# AGENDA SUPPLEMENT (1)

Meeting:	Northern Area Planning Committee
Place:	Council Chamber - Council Offices, Monkton Park, Chippenham,
SN15 1ER	
Date:	Wednesday 17 September 2014
Time:	<u>6.00 pm</u>

#### NORTHERN AREA PLANNING COMMITTEE ADDITIONAL INFORMATION <u>17 September 2014</u>

### Item 6(c) – 14/06724/FUL & 14/06854/LBC – The Stable Barn, Westfield Farm, Nettleton, SN14 7PA

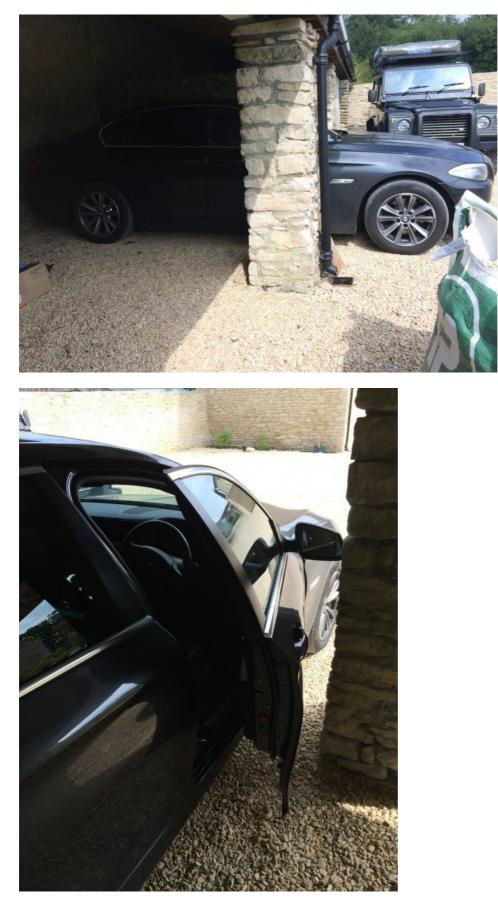
The reference to the 'large four wheel drive vehicle' is also misplaced as the byre identified for 'garaging' in the original 2010 permission cannot accommodate a normal saloon car; please see attached photographs.

The failure of the officer dealing with conservation issues to note that beyond the lawful residential curtilage there exists a range of modern steel framed barns with associated accessways and outside storage areas (please see attached photographs), further confirms that no proper assessment has been made of this site and its surroundings by the Conservation officer.
